PHILADELPHIA ELECTRIC COMPANY

Subject: Limerick Generating Station, Units 1 and 2
Request for Information from the Power
Systems Branch

Reference: Meeting between Auxiliary Systems Branch and
Philadelphia Electric Company on March 30, 1983

The attached documents are draft question response changes and draft text changes to the FSAR resulting from the discussions with Mr. John Ridgely, Auxiliary Systems Branch reviewer, at the referenced meeting.

**LIMITS OF EXCAVATION
FOR
POWER BLOCK
SHEET 1 OF 10**

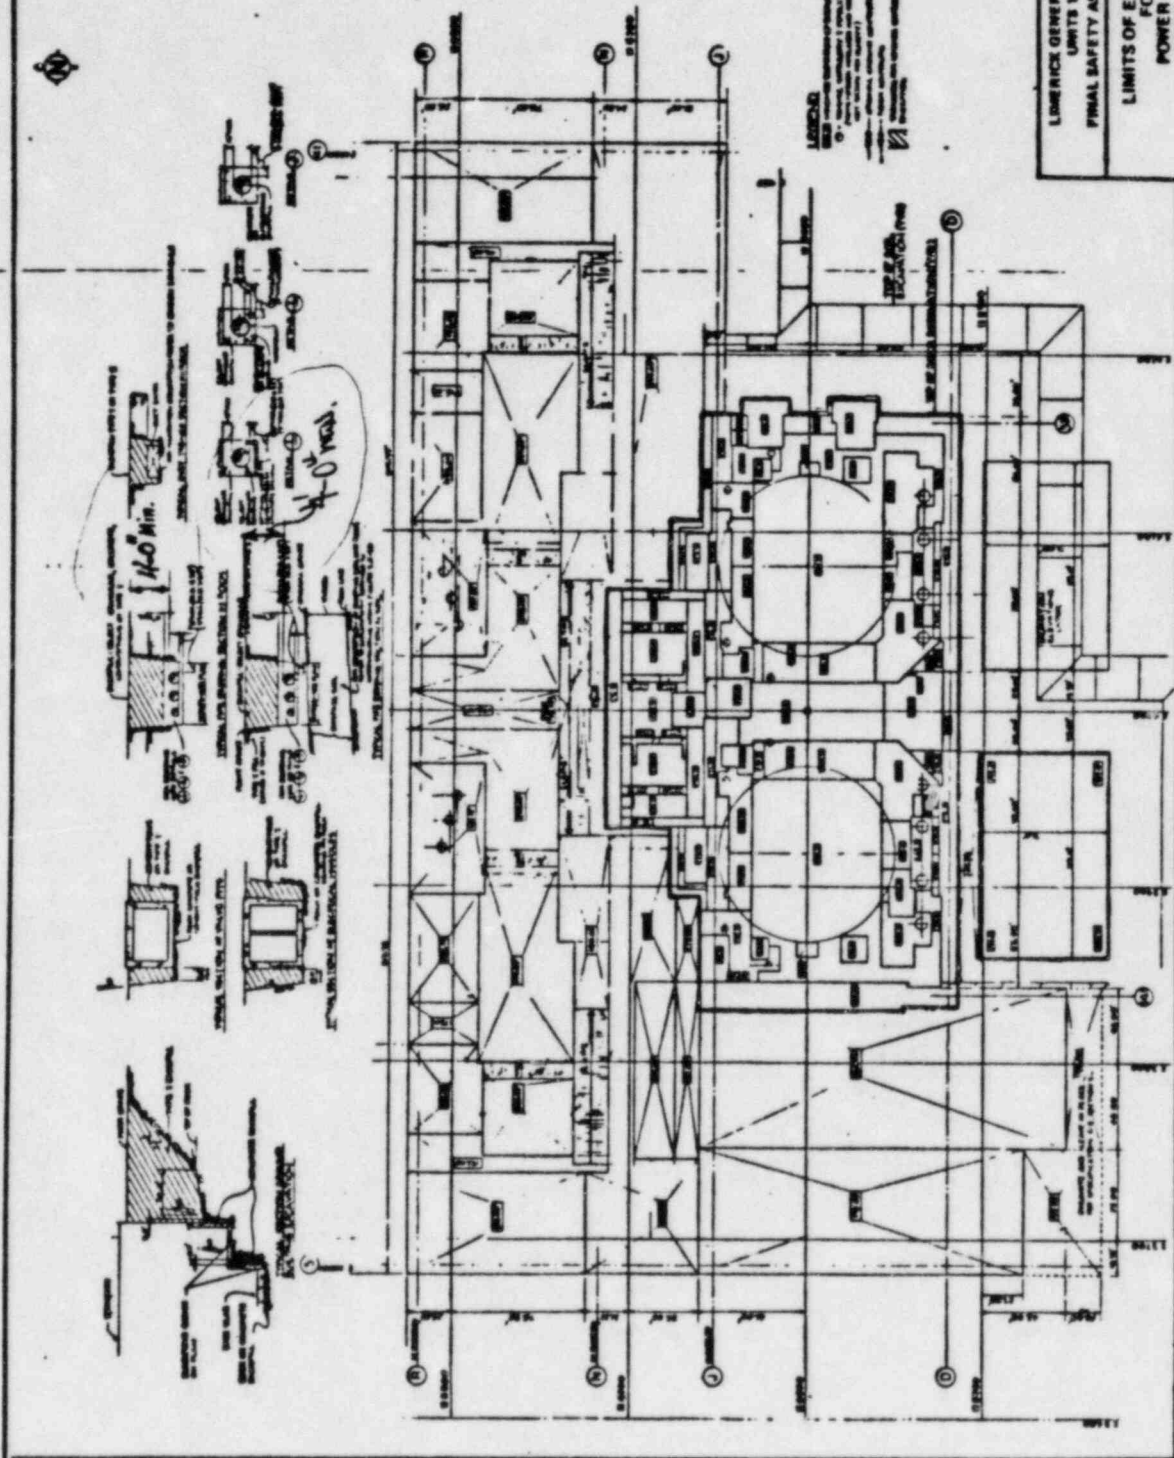
FSAR Table 3.5-7 indicates the emergency service water and RHR service water piping is missile protected by virtue of being buried. Provide drawings which show the physical routing of the piping, the distance from the top of the pipe to grade, and the burial details and discuss the criteria utilized for determining that this amount of protection is adequate.

The physical routing of the piping and typical profiles showing soil cover and installation details are shown in Figure 2.5-37. The cementitious backfill for pipe bedding is shown in Figure 2.5-37, Sheet 1, detail 3. This backfill was used predominantly for Category I piping to provide additional missile protection. The properties of cementitious backfill are defined in Section 2.5.4.5.4.

A detailed assessment of soil cover for Category I yard piping shows a minimum depth of 4 feet, with most soil coverings exceeding 6 feet. The 4-foot depth was found to be adequate for tornado missiles (Table 3.5-4) in accordance with the criteria set forth in "Depth Predication for Earth-Penetrating Projectiles", Soil Mechanics and Foundation Division, ASCE, P. 6558, May 1969. Figure 2.5-37 Sheet 1 has been revised

to show the 4-foot ^{dimension} depth of soil cover for Category I yard piping.
 Minimum

FIGURE 9.3.2

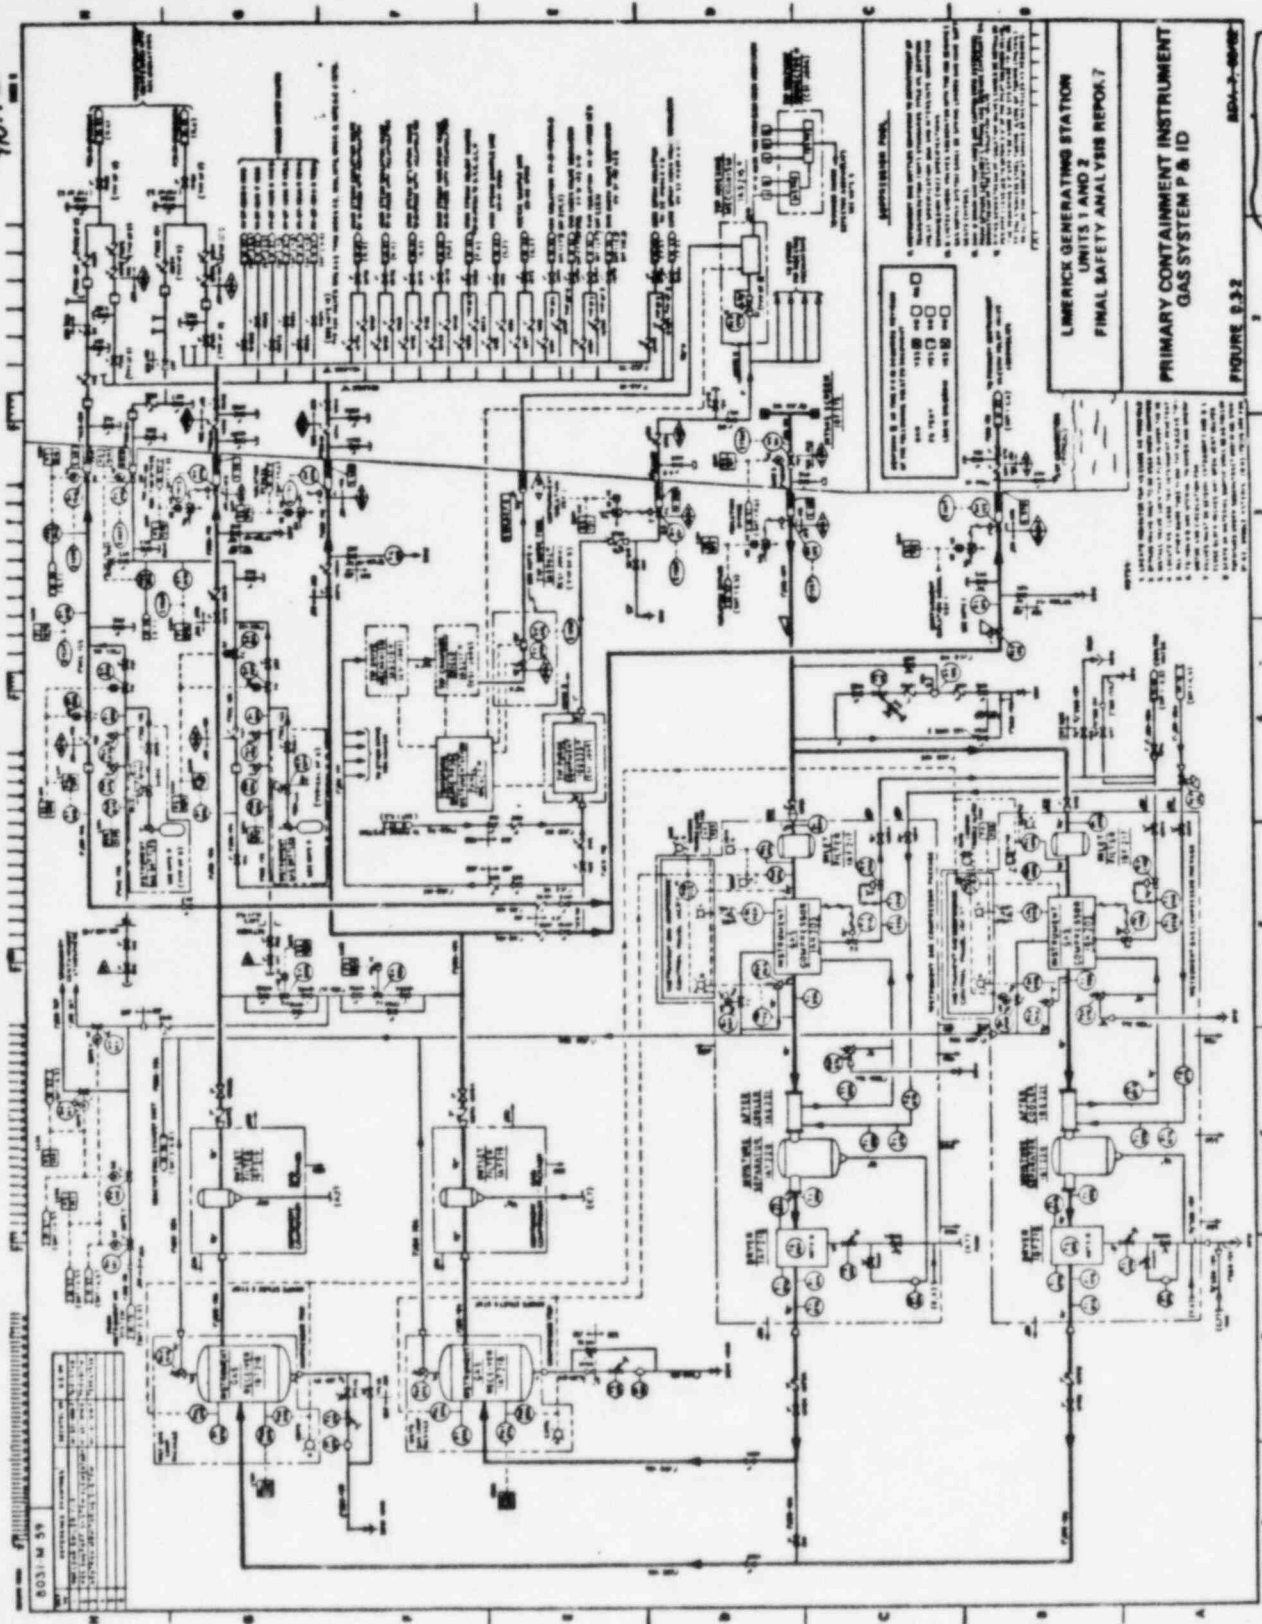
Verify the availability of the 7 day instrument air supply after a safe shutdown earthquake which fails all non-seismic Category I air piping (which includes all 1" JDD-106 air lines). Consider the resultant loss of offsite power and the single failure of valve 1024E.

Two seismic Category I air supplies have been provided to assure the long-term operability of the ADS valves. One air supply serves three ADS valves, the other serves the remaining two. These air supplies have been designed to remain operable following a loss of offsite power. Each is provided with an external connection which may be used to provide pneumatic pressure for periods beyond 7 days. Redundant automatic valves are provided to isolate the seismic Category I portions of the system from the non-seismic Category I portions. These two air supplies are physically separated such that no single failure can prevent the required long-term operation of the ADS valves.

Figure 9.3-2 has been revised to correctly show the connections of Seismic Category I and IA lines.
